Agenda
Village of Arlington Heights
Design Commission
Community Room, 3rd Floor

- A. DC#18-078 - Stonebridge Apartments - 650 W. Rand Rd. / Multi-Family
- B. DC#18-079 - Sign Code Modifications
Residential Wall Signs, Wall Signs for Multi-Story Buildings,
Awning Signage, Perimeter Window Lighting, Window Signs

Stonebridge Apartments
Exterior Facade
Improvements
600 West Rand Road
Arlington Heights, Illinois 60004
Project No. 13663

Field Mockup of Proposed Color Scheme

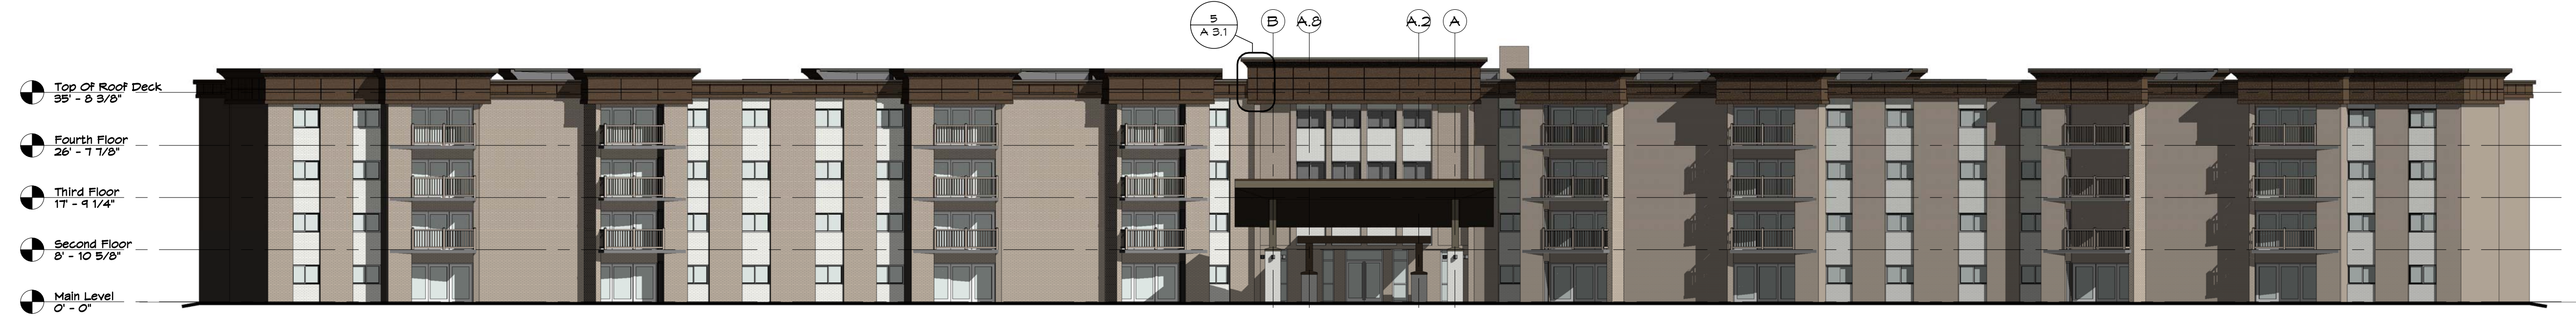
- **Balcony Railings:** The proposed "Black Fox" SW 7020 color for the balcony railings looks great, and would add some nice contrast to the large buildings. However, painting prefinished vinyl railings raises serious concerns about long-term durability and maintenance.

- **Landscaping:** The existing buildings have sparse landscaping around the base of the buildings. To enhance the appearance of the buildings, foundation plantings are recommended around all of the buildings with a variety of shrubs and perennials.

1. A recommendation to continue the review of the revised exterior paint colors until an acceptable response is received regarding the illegal tree removal and required tree replacement.

8. **Landscaping:** It is recommended that the foundation plantings around the base of all of the buildings be enhanced with a variety of shrubs and perennials.

7 Low Profile
A 3.1 1/2" = 1'-0"

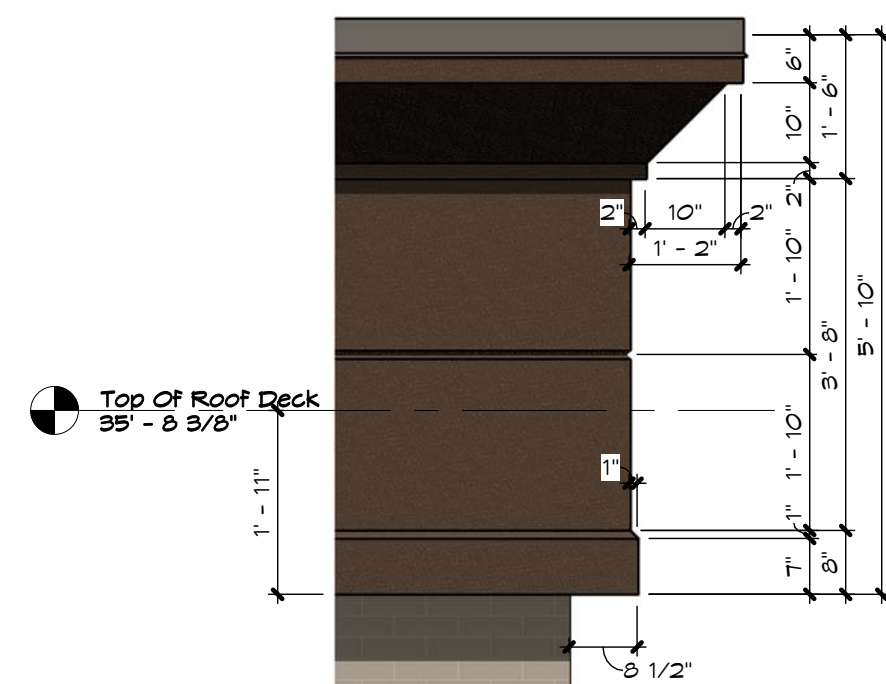
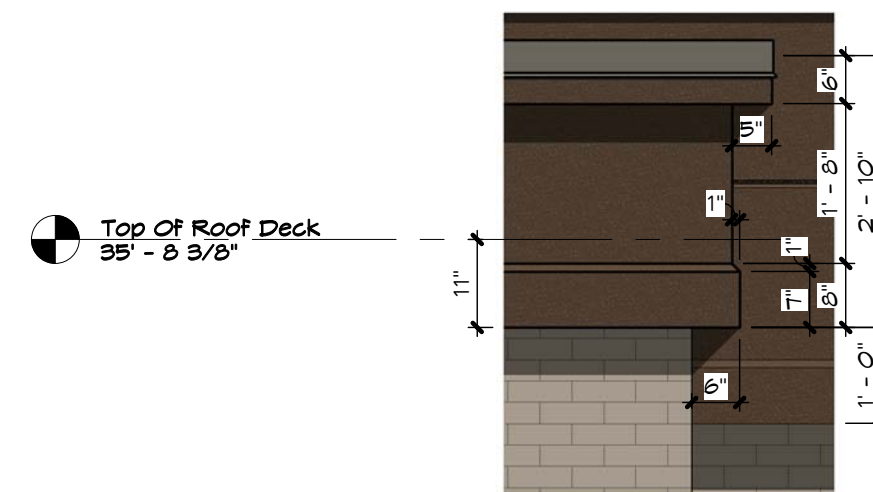
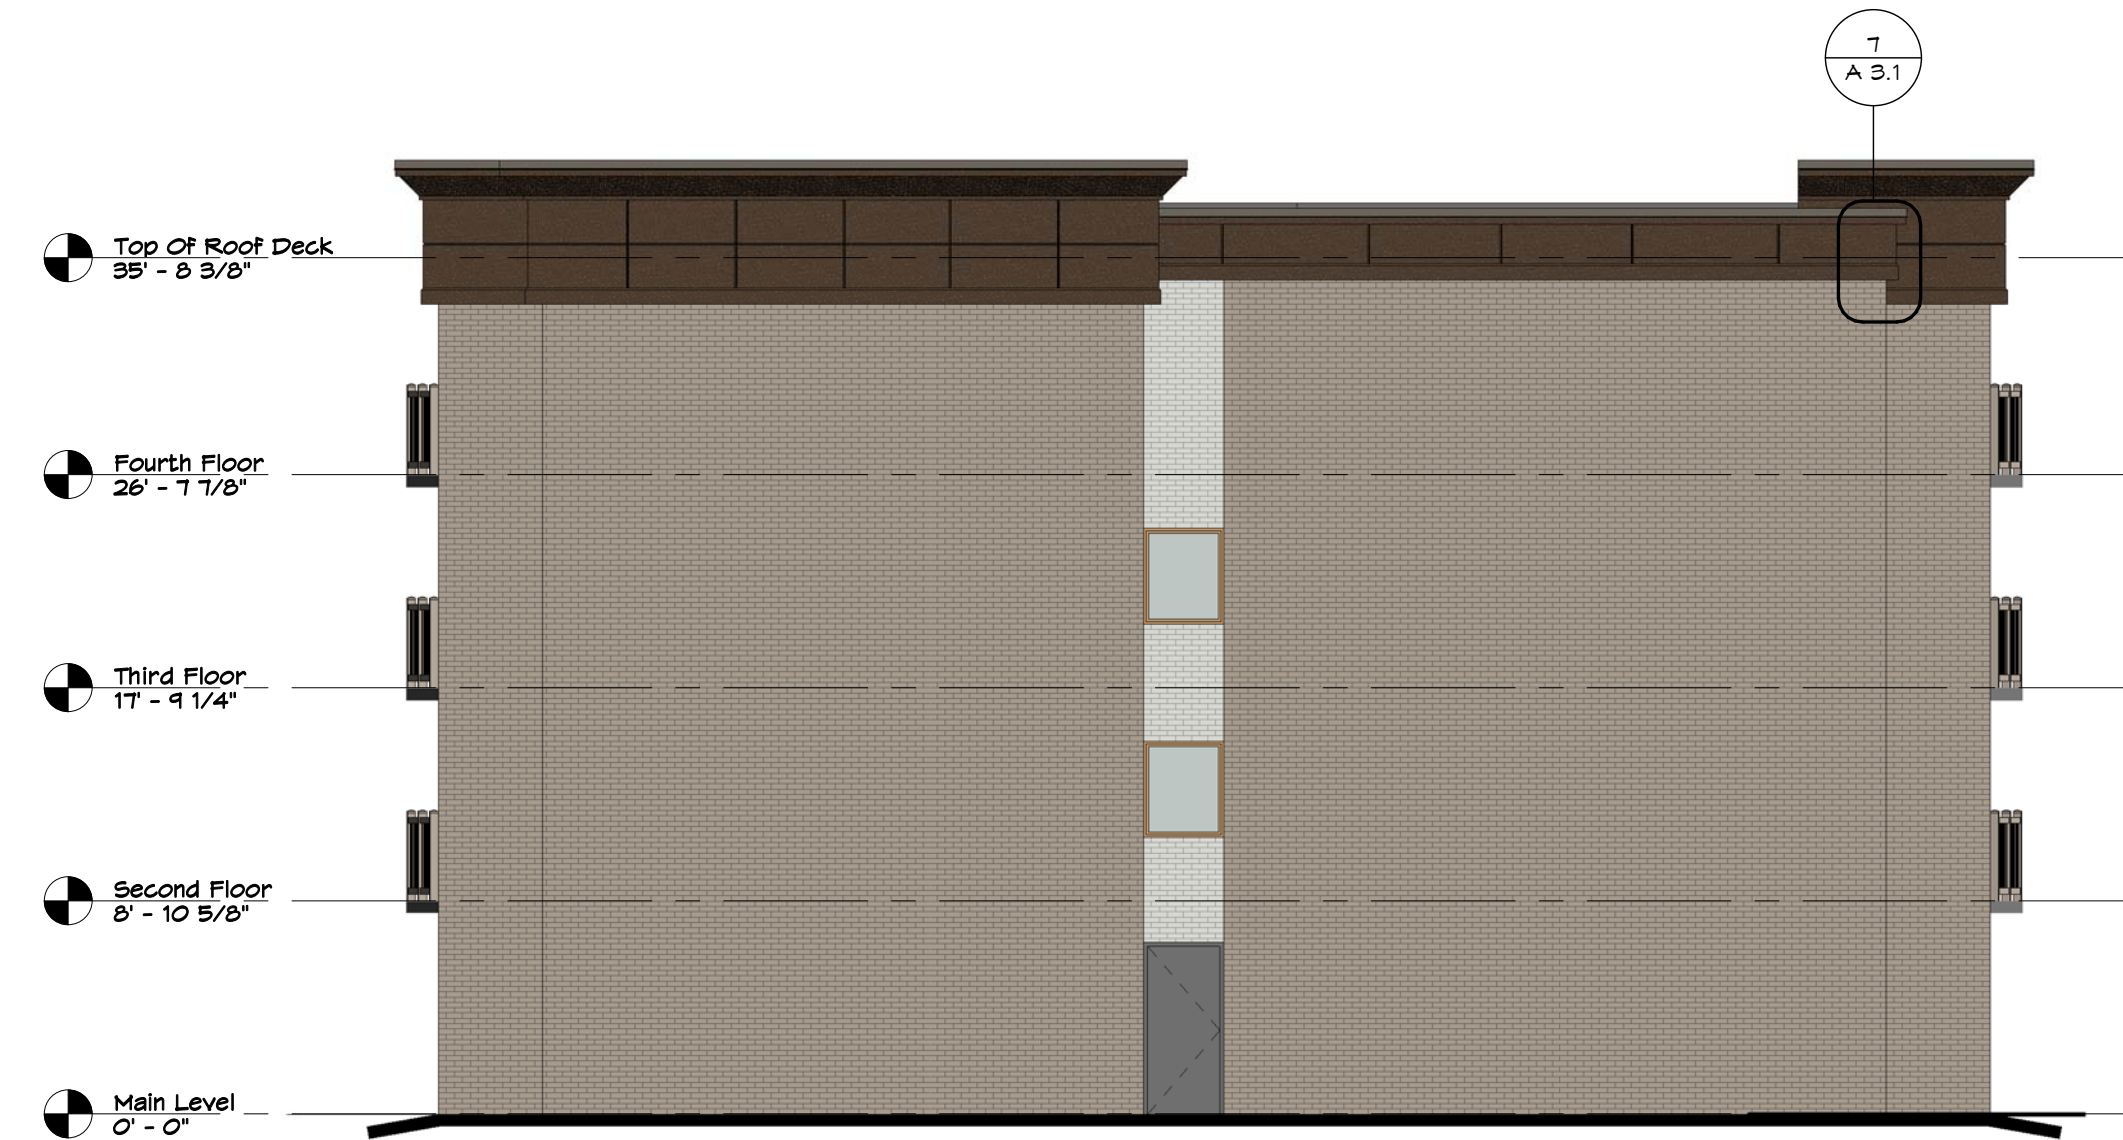
- a. Overall, the revised cornice design is a big improvement. It has much better scale and proportion.
 - b. It is recommended that the bottom of the “low” profile cornice be raised up about one foot to break the continuous horizontal line.

1. Raise the bottom of the “low profile” cornice detail about one foot.
2. Study a new paint scheme with dark brown cornice, beige walls, and off-white spandrel panels, field mockup to be approved by Staff.

Renovated Exterior
Elevations

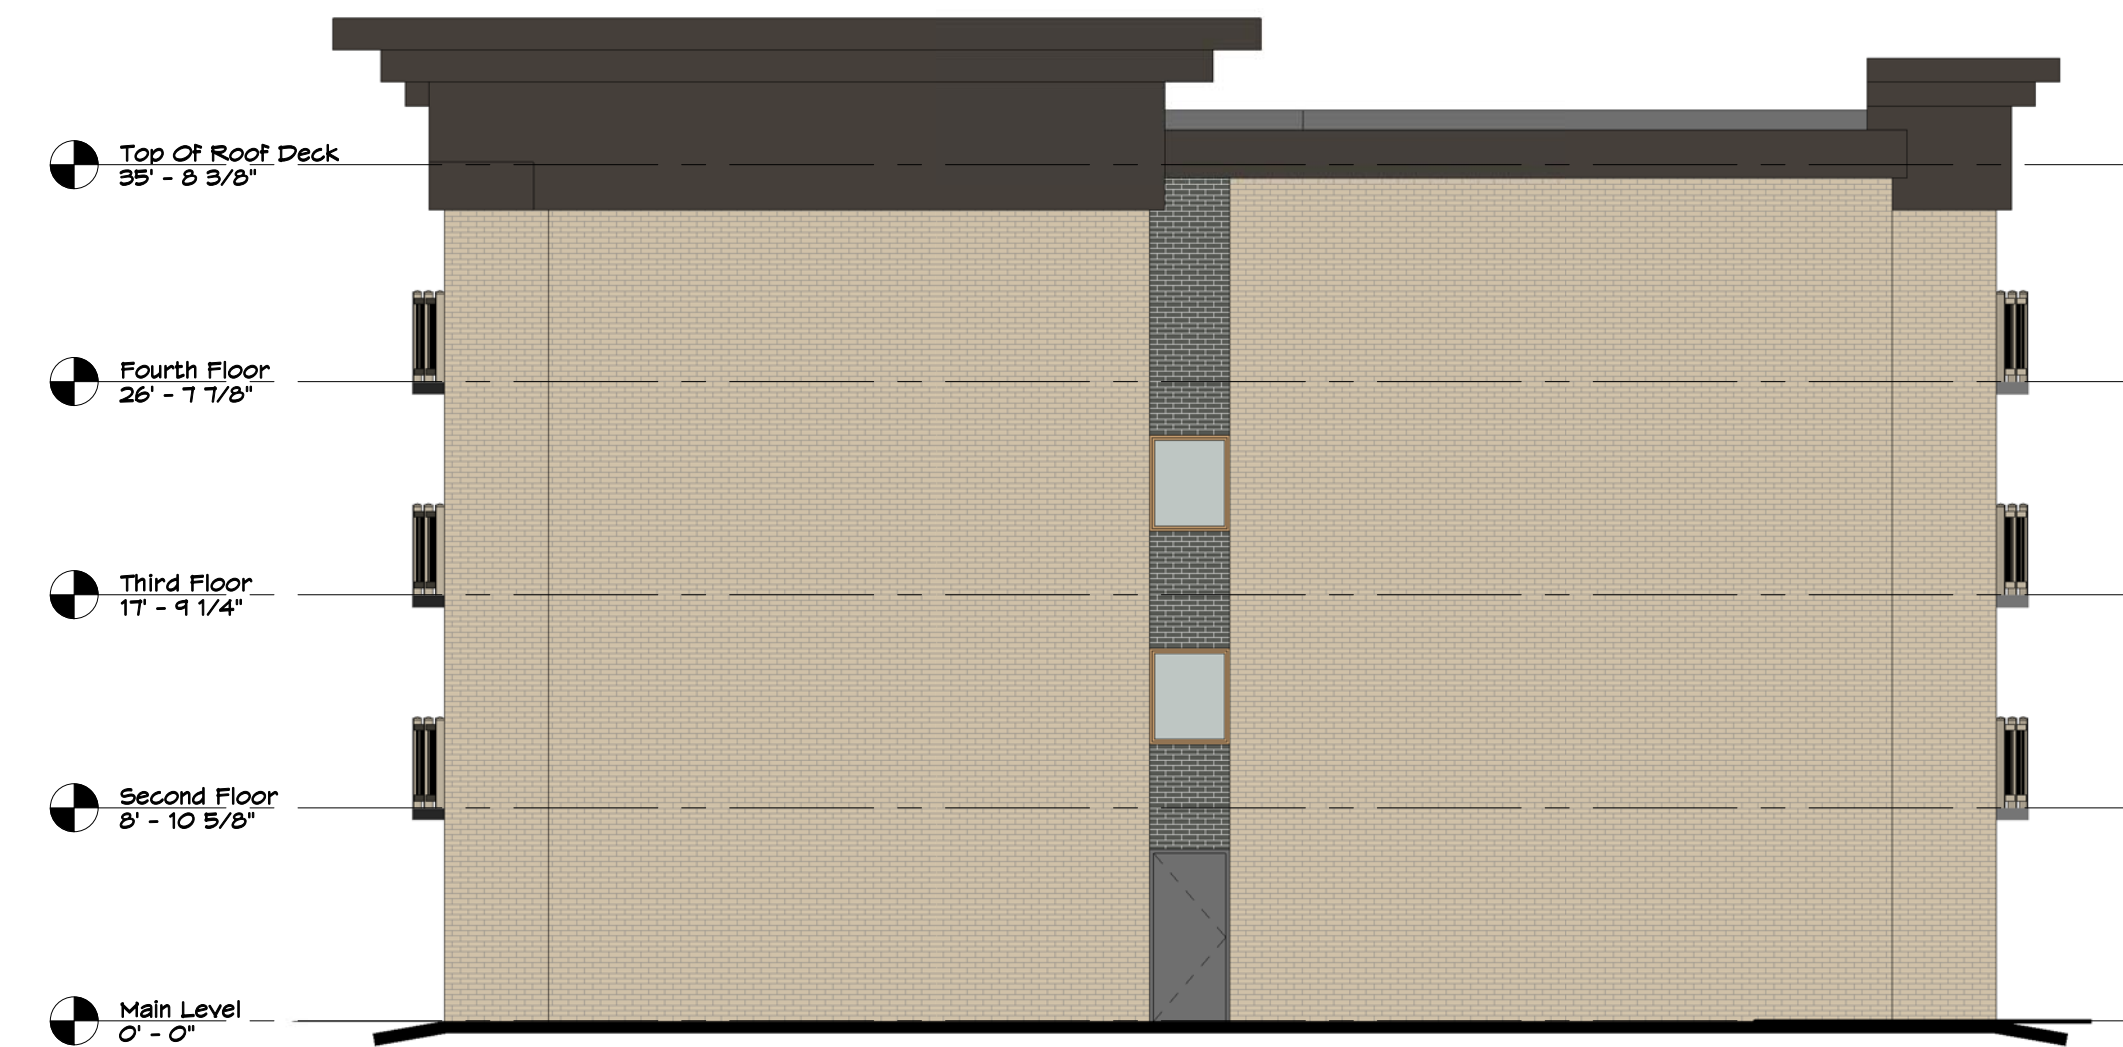
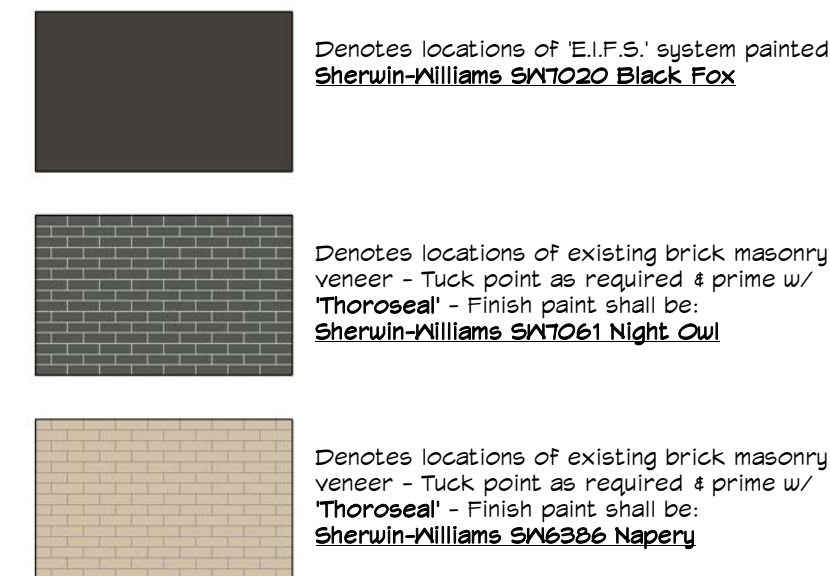
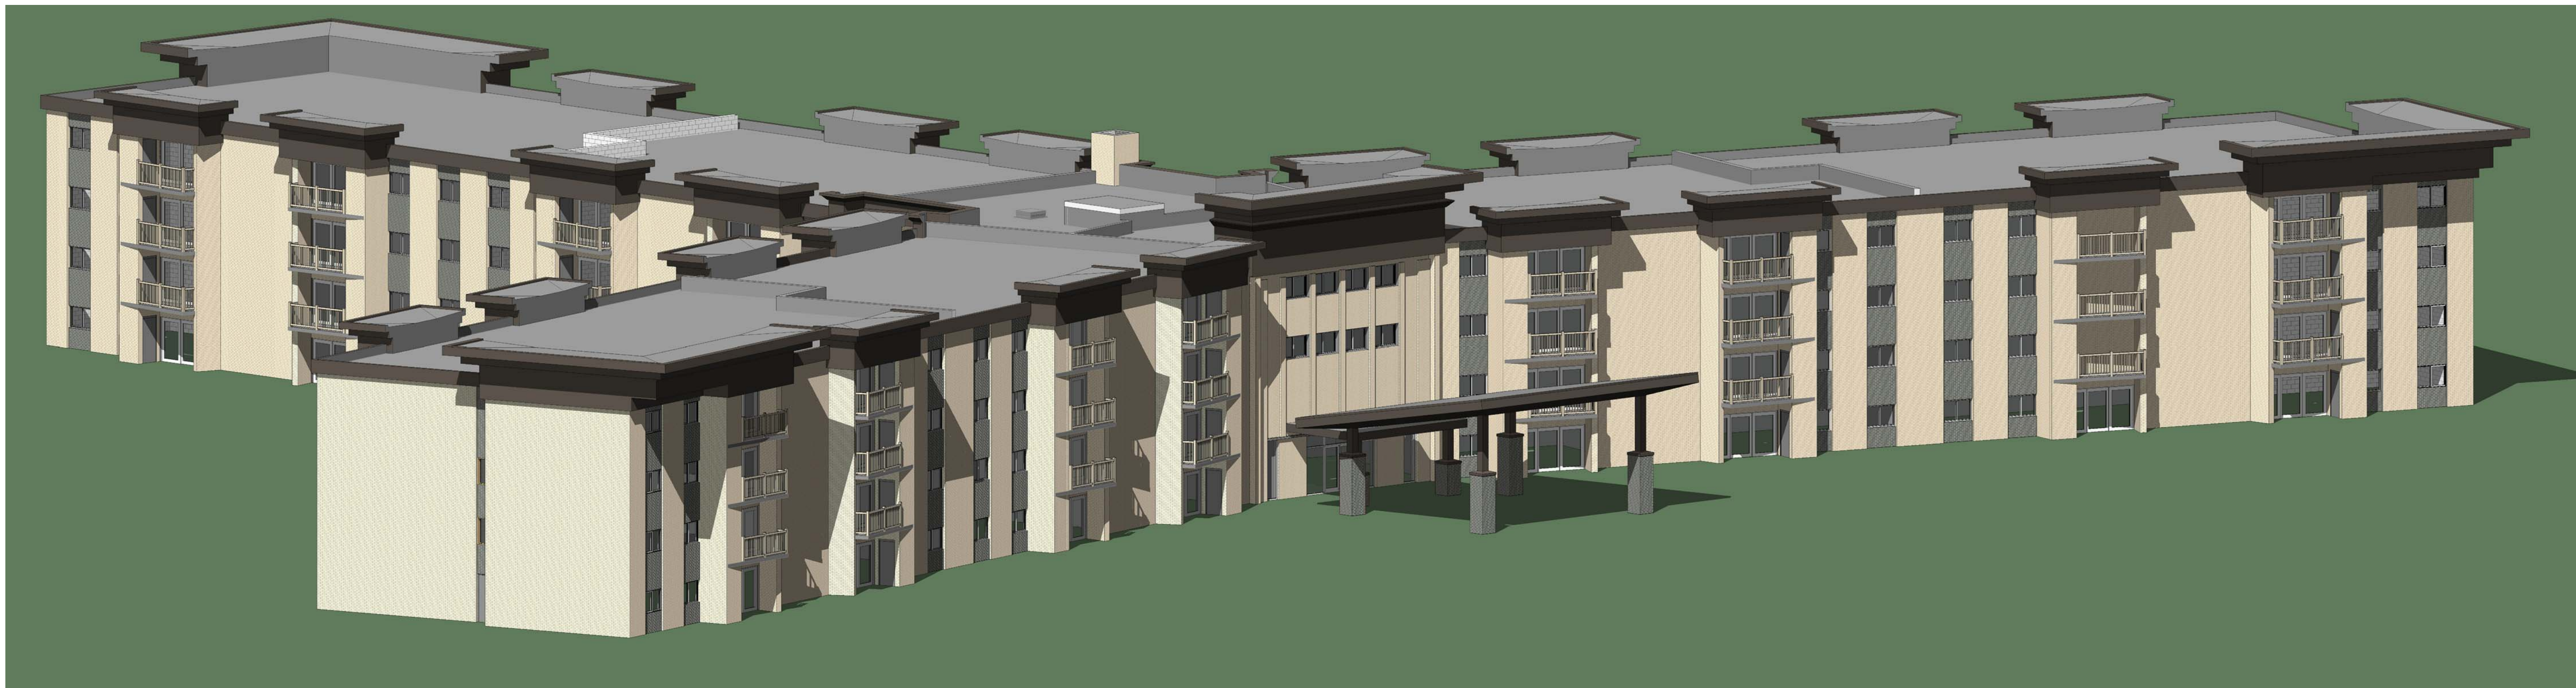
1. Cornices. Overall, Staff is in support of the concept to use a bold decorative cornice to give the buildings a fresh, modern appearance. However, portions of the proposed cornice design look a bit heavy and bulky, especially in the dark black color. Additionally, the profile of the cornices is a simple stepped design. Consider incorporating a slope into the bottom of the profile to add more interest to the design. The scale, profile, and color of the proposed cornices should be evaluated by the Design Commission.

1. Evaluate the scale, profile, and color of the proposed cornices. Consider incorporating a slope into the bottom of the profile to add more interest to the design.
